AA 381-07 The Villas @ Severna Park
SUB 07-0112 Addition

STATE OF MARYLAND
CRITICAL AREA COMMISSION
CHESAPEAKE AND ATLANTIC COASTAL BAYS

December 10, 2009

Re: The Villas at Severna Park
S01-038, P 07-0112 00NF

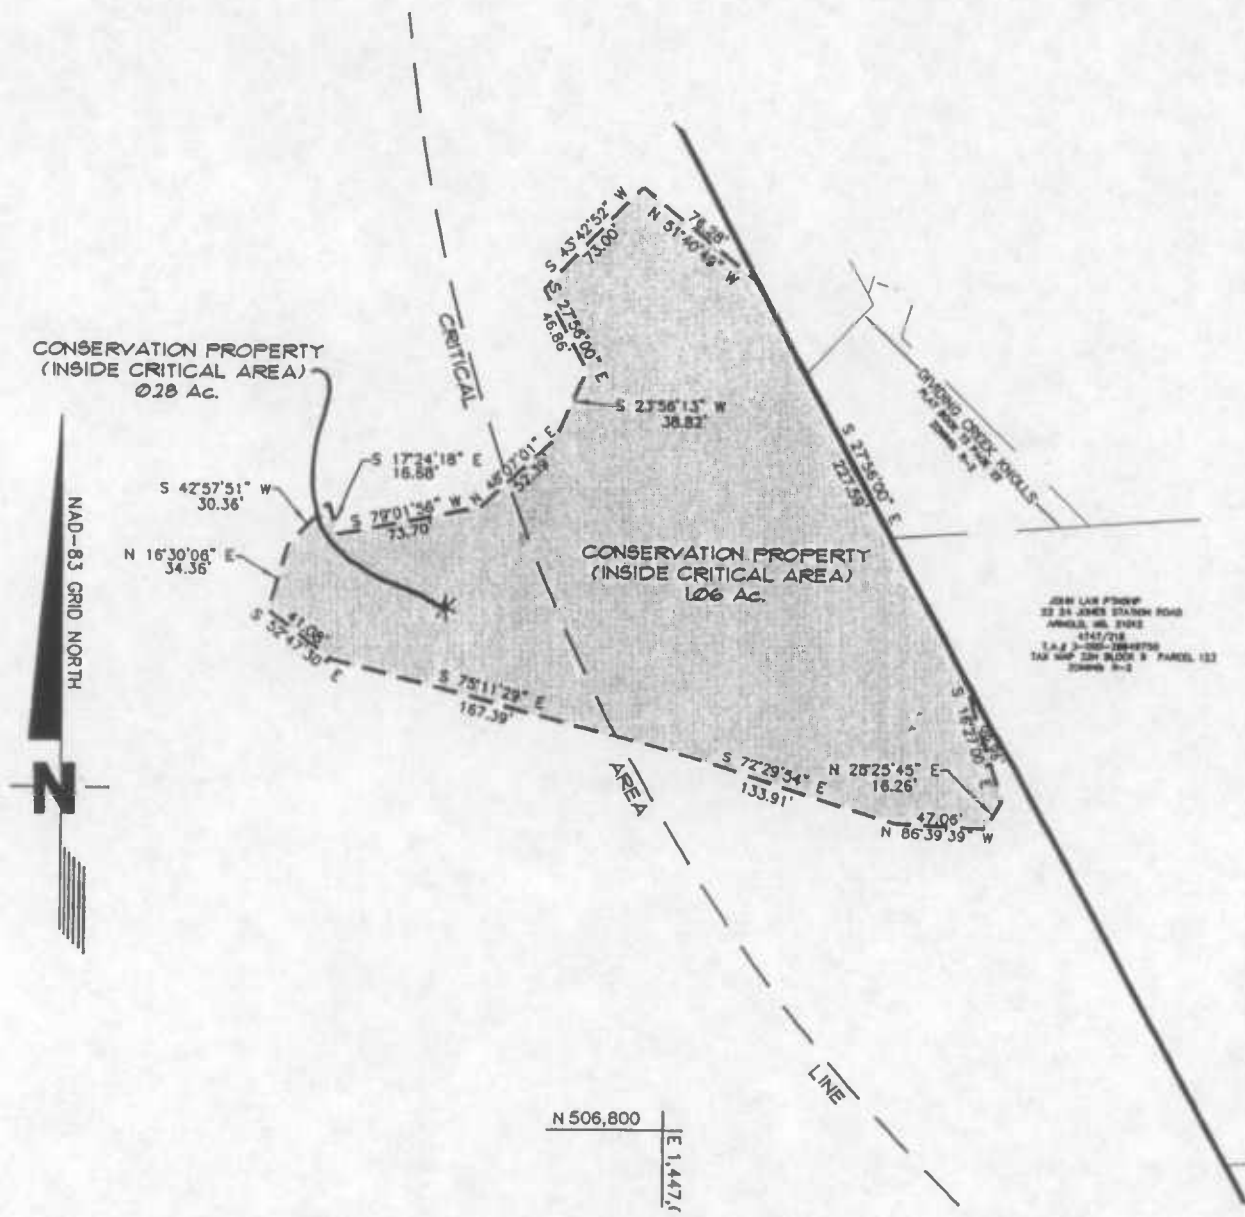
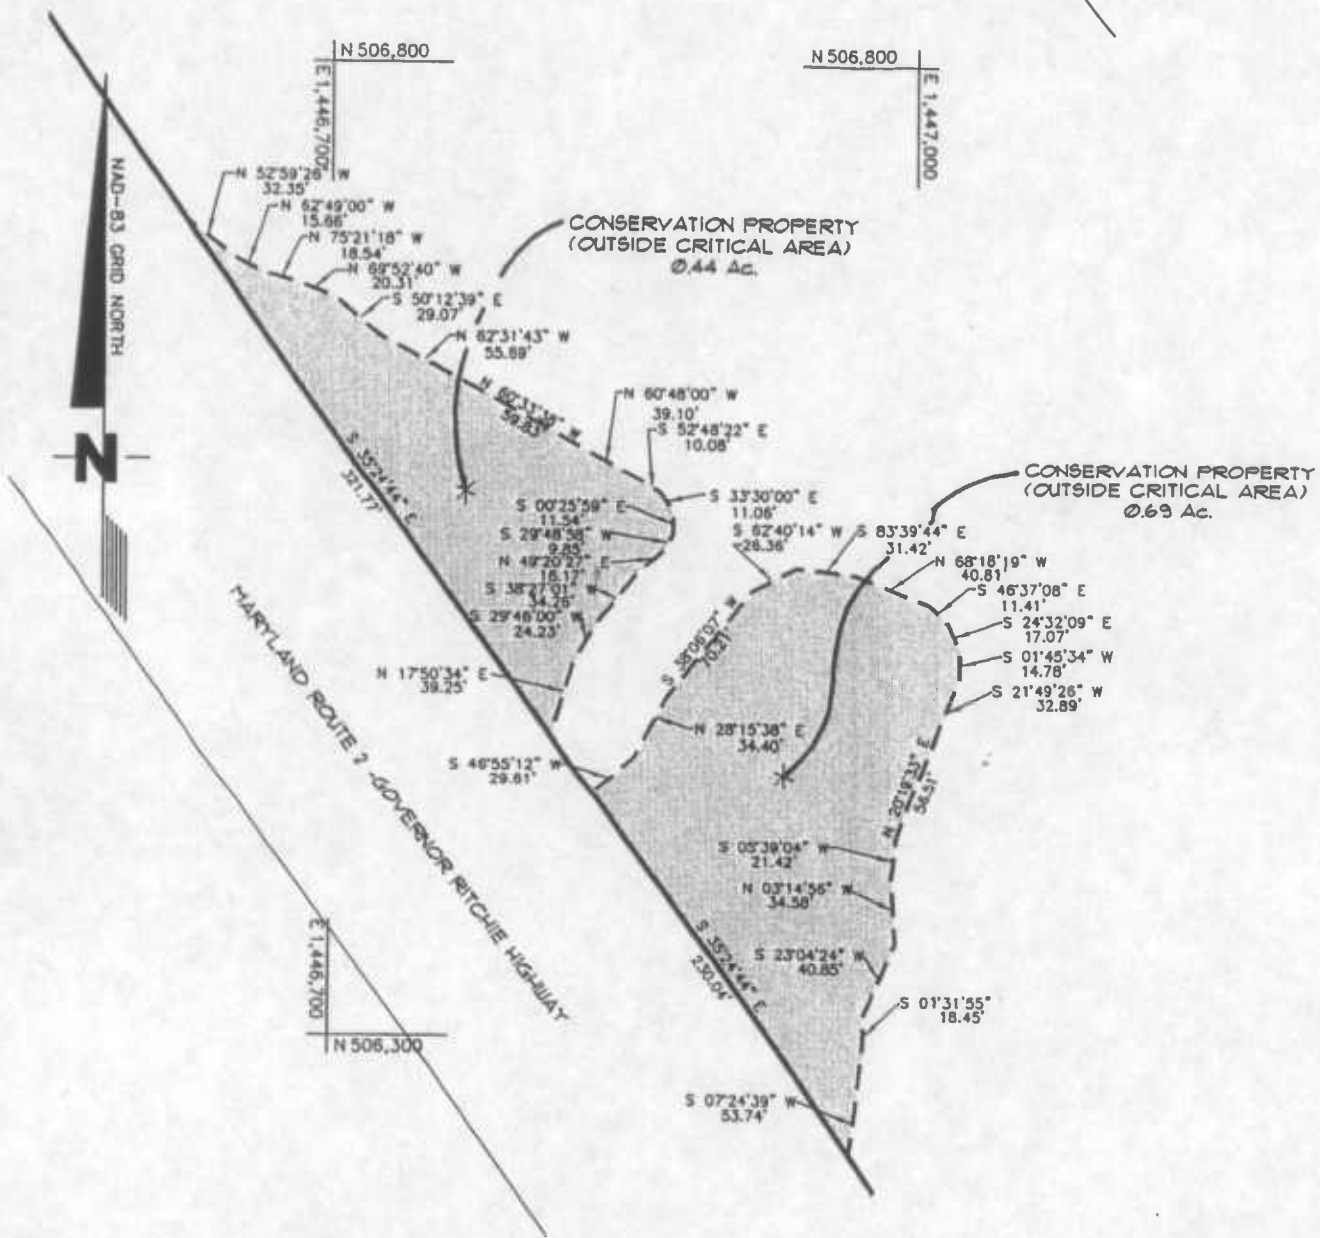
9. The applicant has noted that 70% of the existing forested area within the Critical Area, or 3.95 acres, has been placed in a conservation easement. However, it is unclear where these 3.95 acres are located. I was only able to locate the 1.05 acres of protected forested area labeled as "Critical Area Conservation Property." Please clarify where the other 2.9 acres of protected forested area is located within the Critical Area on the property. Also, please include this conservation easement area on the plat. If only the 1.05 acre conservation property is proposed, we note that this is only 52% of the existing 2.02 acres of existing forested area within the Critical Area portion of the bulk parcel. Under COMAR 27.01.02.04.C(3)(c) no more than 20% of any forested area may be removed from use and the remaining 80% shall be maintained through recorded, restrictive covenants or similar instruments. Therefore, it appears that at least 1.61 acres of existing forested area within the Critical Area portion of the bulk parcel should be included within the proposed easement. If this can not be accomplished within the proposed footprint of development, the applicant may need to reconfigure the proposed lot lines or reduce the number or lots to meet the development requirements.

RECEIVED
 SHEET 2 of 10
 FINAL PLANS
 THE VILLAS AT SEVERNA
 ADDITION
 OCT 19 2009
 CRITICAL AREA COMMISSION
 Chesapeake & Atlantic Coastal Bays

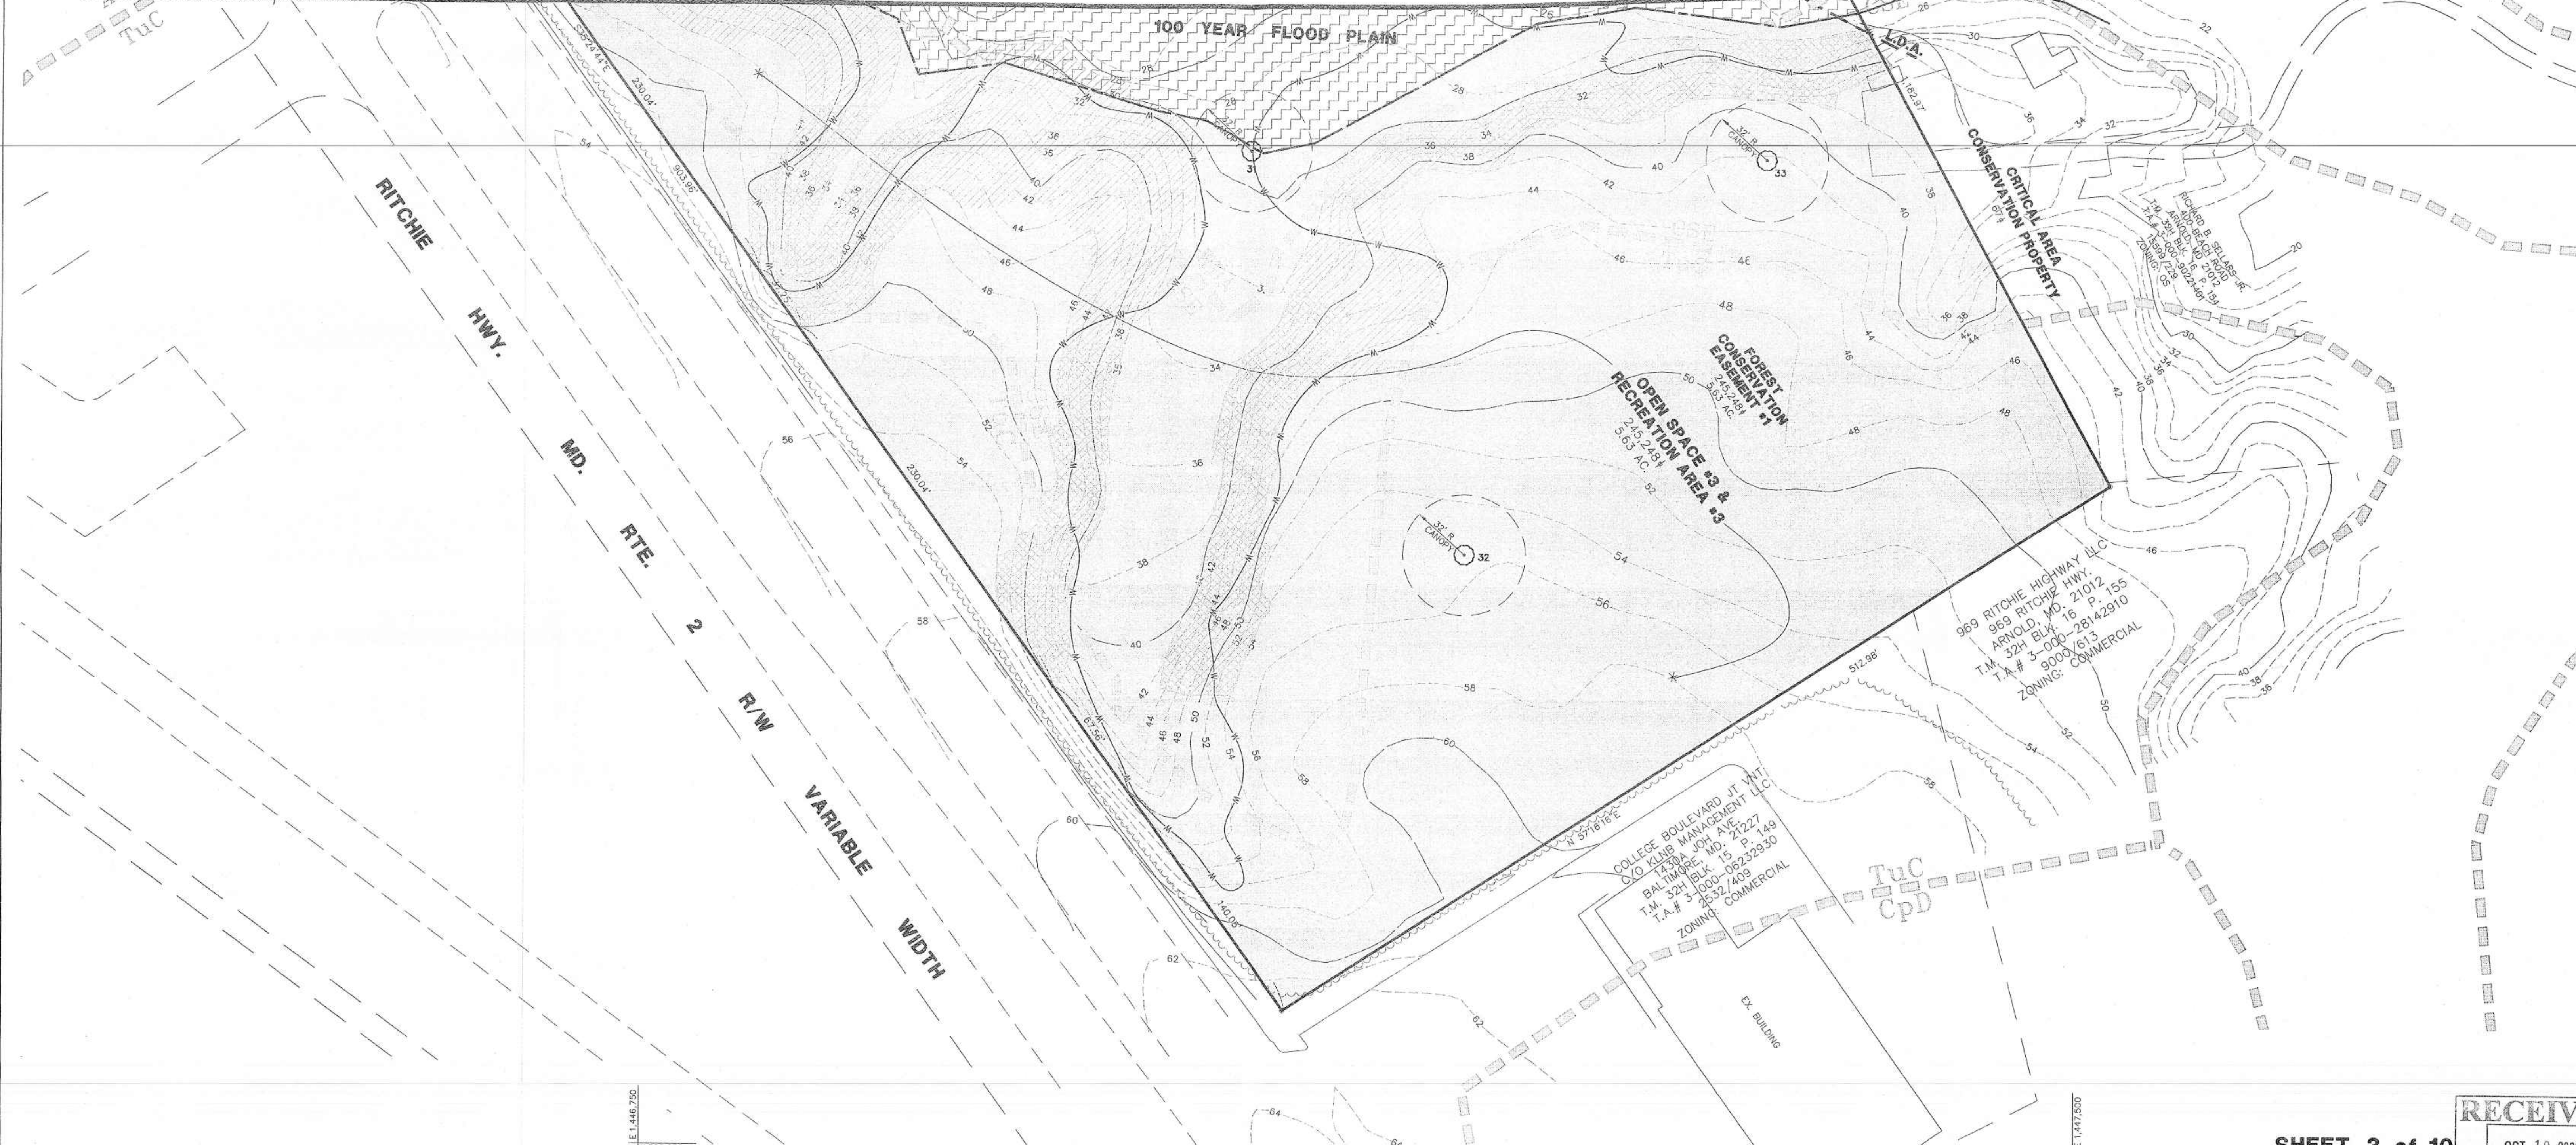
1. The applicant previously indicated that additional information would be submitted to address the following comment with future submittals. However, the revised plans have not addressed this comment. Based on aerial photography and the State's wetland resource maps, it appears that there is a stream that flows through the floodplain to the rear of proposed lot 29. As clearly stated in State Law and in County Code, intermittent and perennial streams are classified as tributary streams where they flow through the Critical Area. These streams require a 100-foot Buffer that is measured from the landward edge of the bank on both sides. This Buffer may be expanded to include contiguous hydric or highly erodible soils and slopes 15% or greater.

- Please have the applicant label the stream and map the Buffer on the plans as based on a field delineated survey.
 - It appears that the Buffer may overlap with the proposed lot lines of lots 28 and 29. If so, it may be necessary to reconfigure or reduce the proposed number of lots. Disturbances within the Buffer on a newly created lot will require variances, which this office can not support. Therefore, we recommend that no new lots be created within the 100-foot Buffer.
